Deck Repair

Meridian

(Construction Plans, Sheet A1.1)

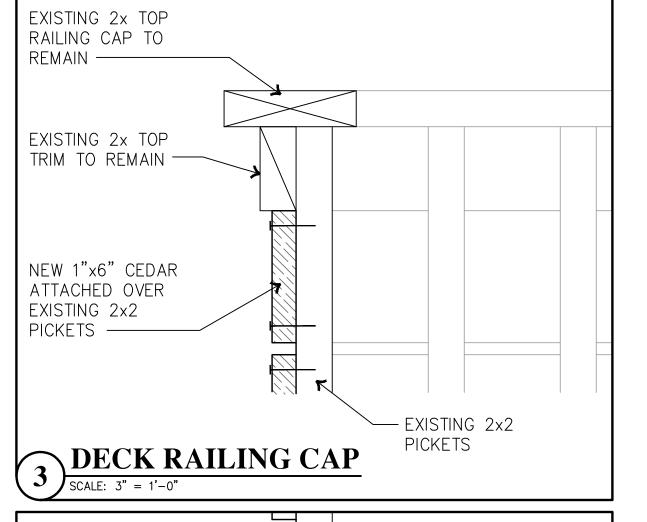
Determine the minimum required specifications for deck beams, posts, post bases, post caps and footings if replacements are necessary. Given the work already completed and the stop-work order in place, establish a clear benchmark to assess the completed work and provide clarity for future construction and inspection, minimizing any potential ambiguities.

(Construction Plans, Sheet A1.1)

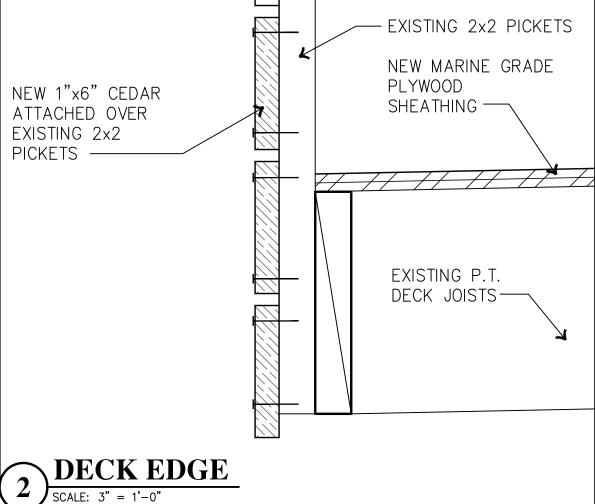
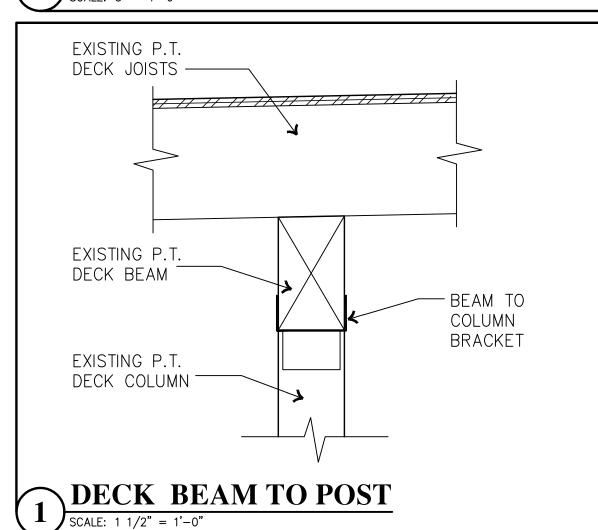
Deck joists appear to be sloped to drain off of the cantilevered side of each deck based upon details 1 and 2. Detail 2 shows the installation of the 1x6 cedar board over the existing 2x2 balusters. detail or notate how the 1x6 cedar will be installed to prevent drainage and water accumulation on the deck surface.

(Construction Plans, Sheet A1.1)

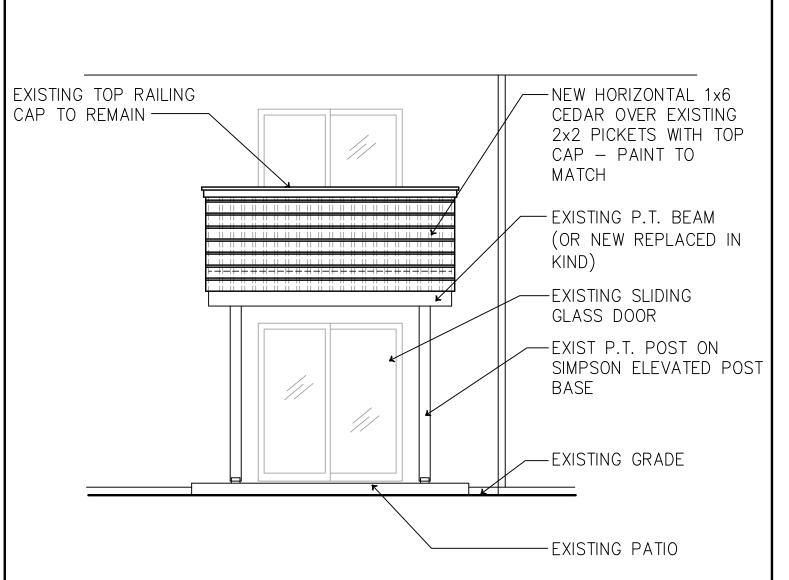
Add a notation on either Sheet A1.0 or A1.1 that contractor shall verify the integrity of balusters prior to the installation of the 1x6 cedar. Establish the parameters of the balusters replacement to include type, grade and nailing pattern.
